3 October 2012

RE: Macarthur Road, Spring Farm – Flood Impact Assessment – Additional Information in response to OEH Letter Dated 24 September 2012 and DoPI enquiries dated 26 September 2012 (transcribed via email from Matt Collins)

Figure 3 - 100 Year Existing Flood Hazard (Velocity x Depth)

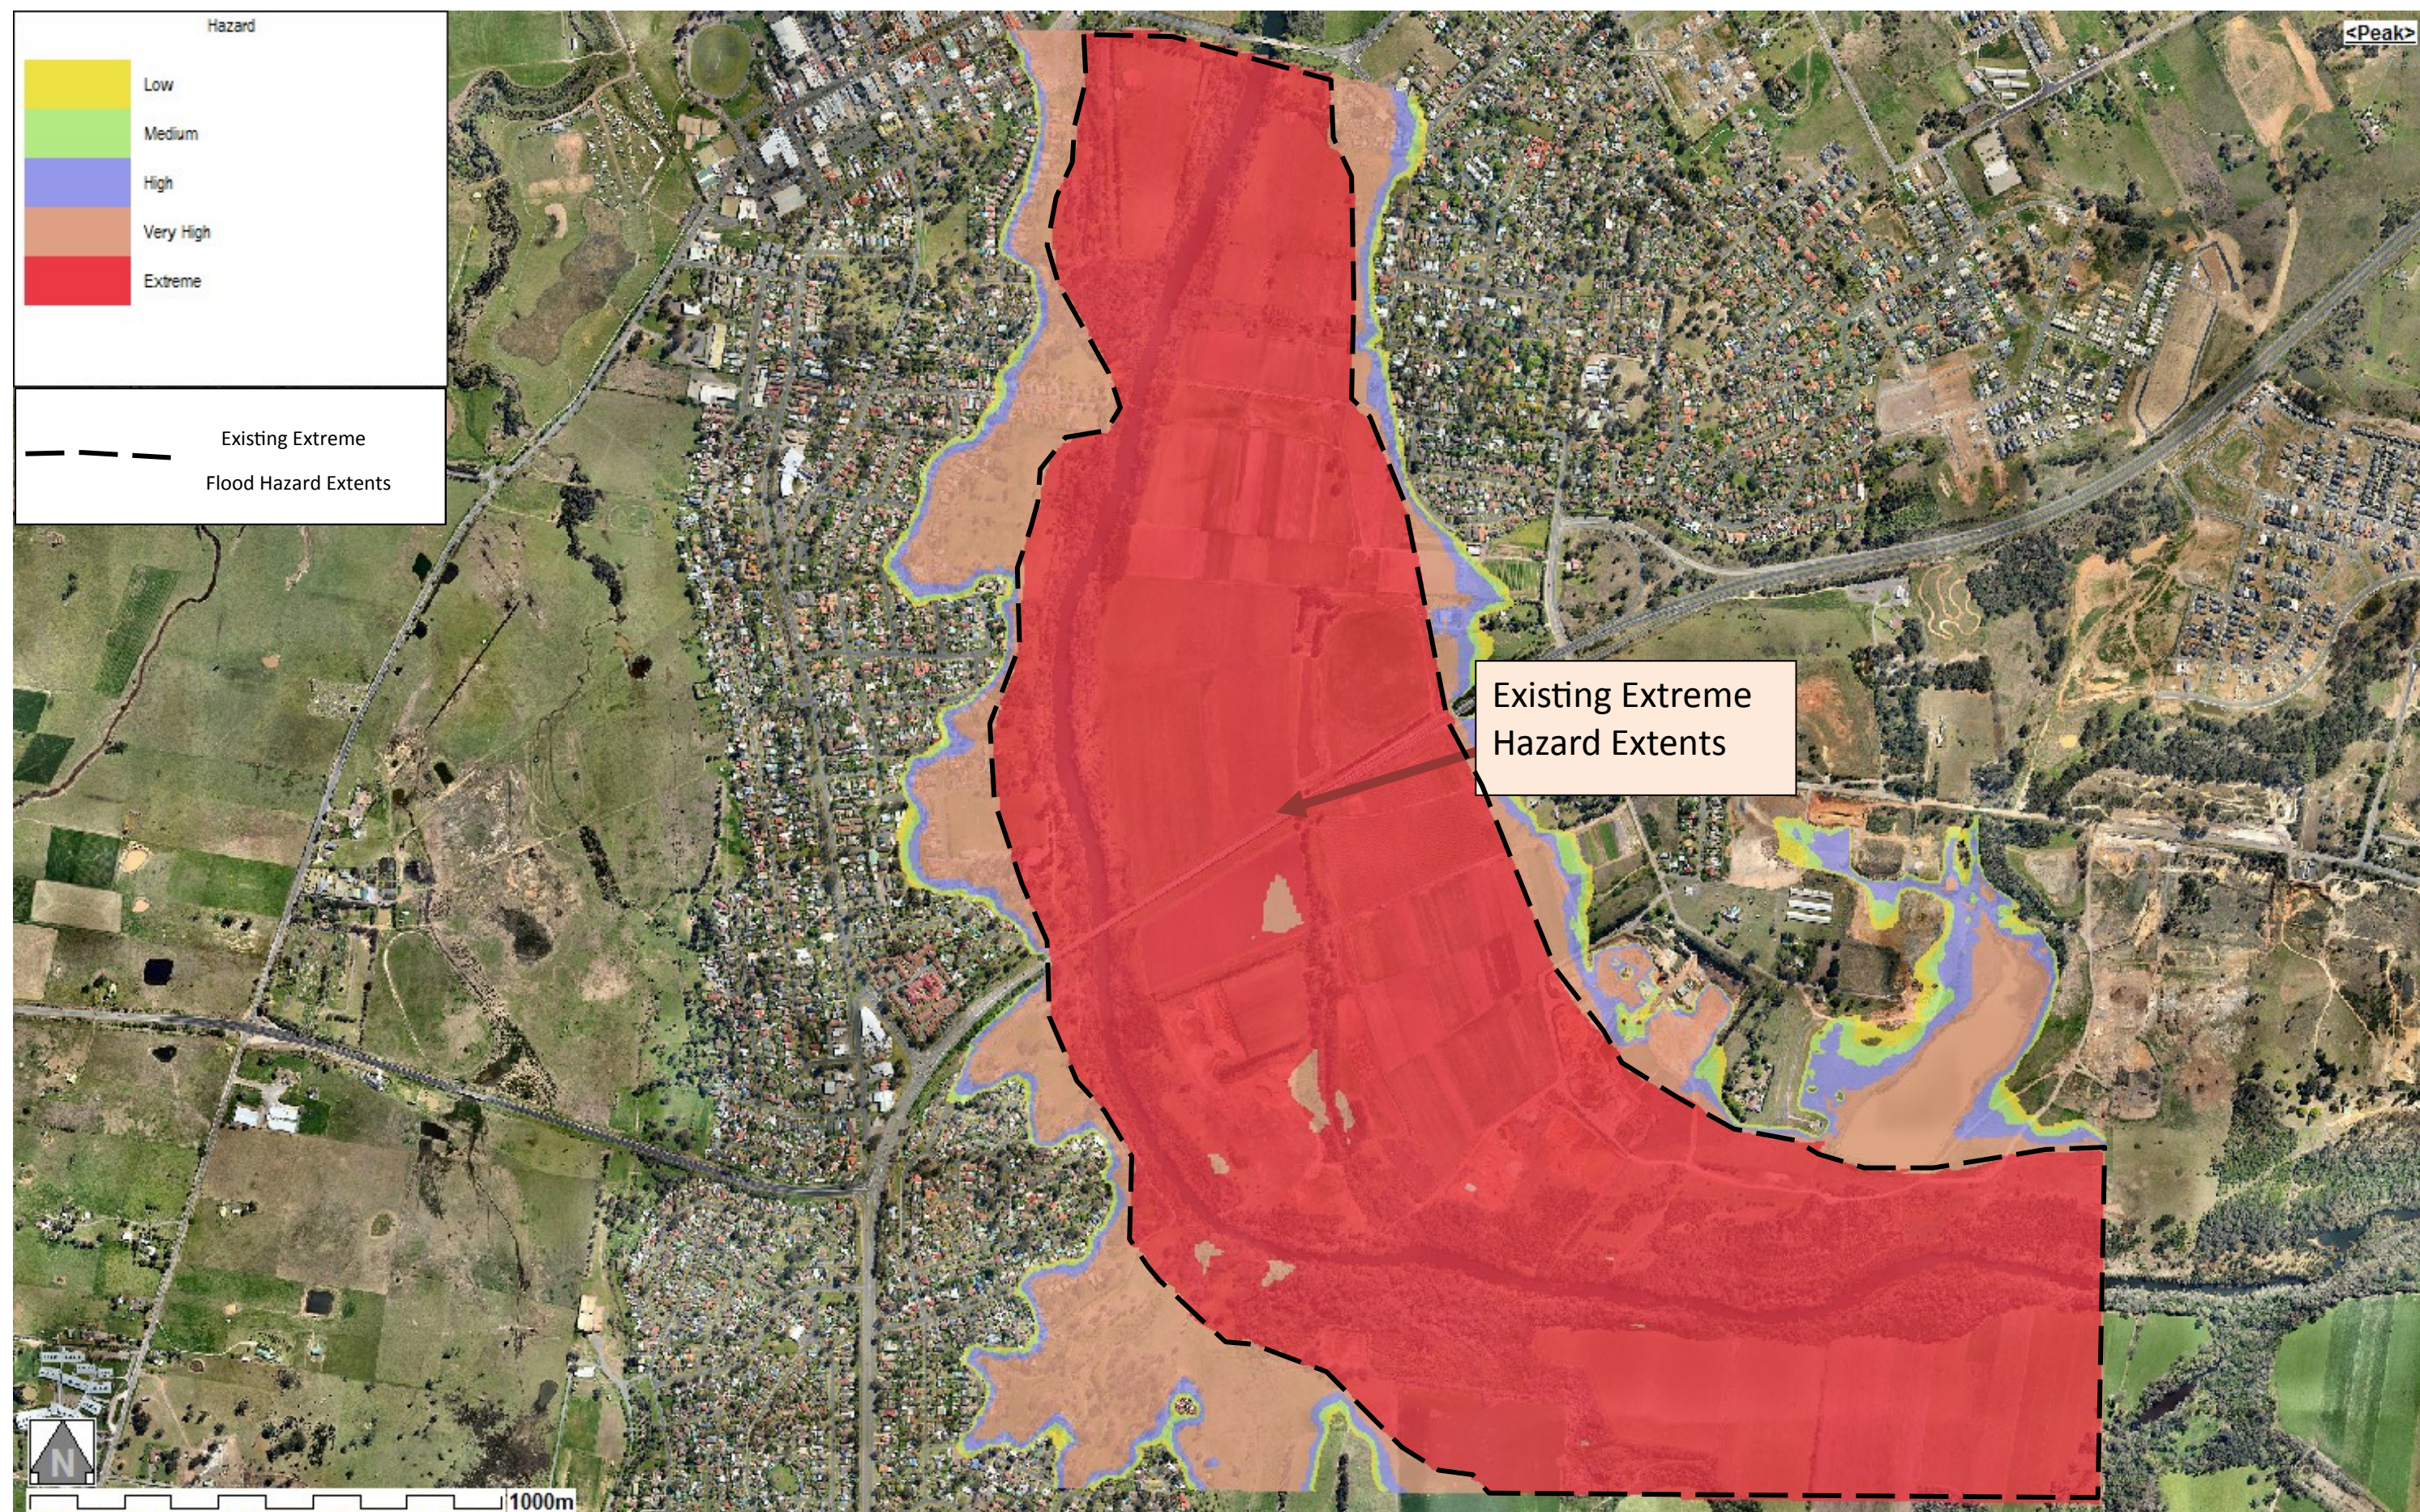
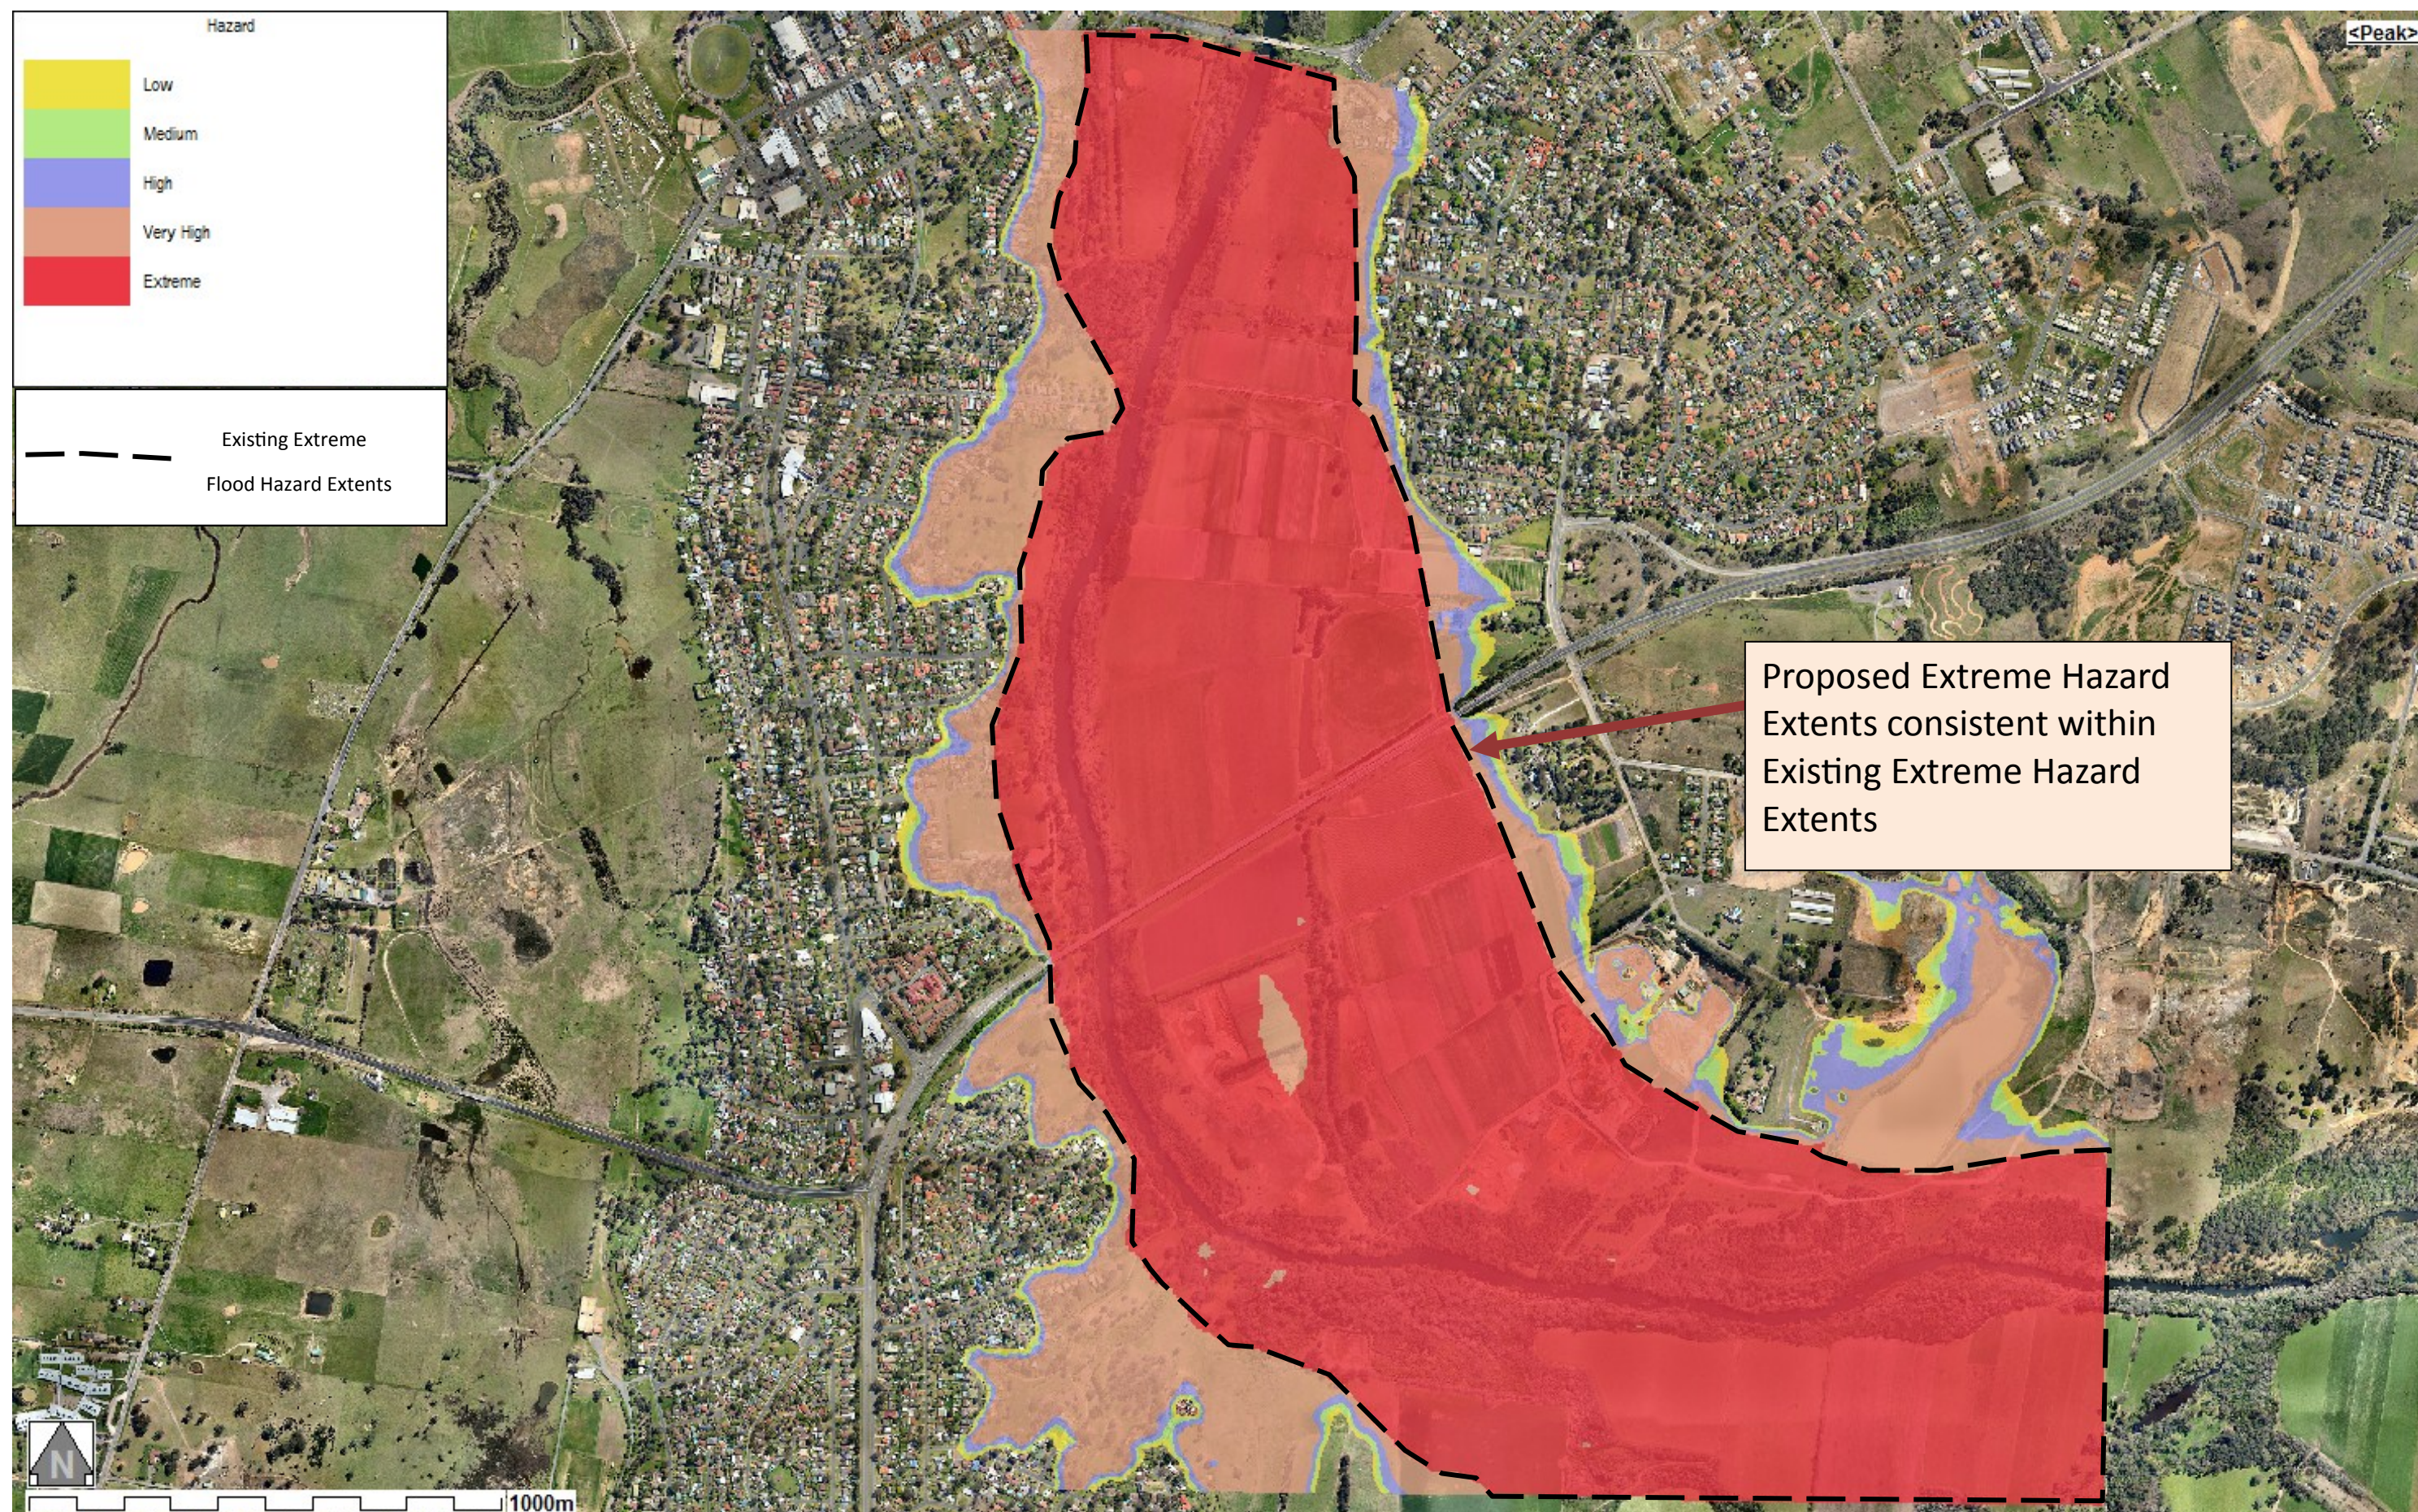
This report aims to address additional concerns raised by OEH in relation to the development, in particular the comment that reporting had not documented the effects of the development on flood levels and flood hazard at adjoining properties.

Figure 3 attached shows the existing Flood Hazard for the 100 year ARI, while **Figure 4** shows the Flood Hazard for the proposed case, for the 100 year ARI, and **Figure 5** shows the differences in the Flood Hazard for the 100 year ARI.

These results show there are no significant flood hazard effects predicted outside of the subject site for a range of recurrence intervals modelled, with the main effect being due to velocity changes post development being localised mostly within the subject site. For example, the model predicts velocity increases along the western boundary of the site (i.e. along the right bank of the Nepean River), as reported previously, and in some areas, the flood hazard changes accordingly, due to slight changes in velocity.

The modelling has demonstrated that adjoining and downstream properties are not impacted in terms of flood hazard, by the influence of floodwater as a result of the proposed sand extraction development.
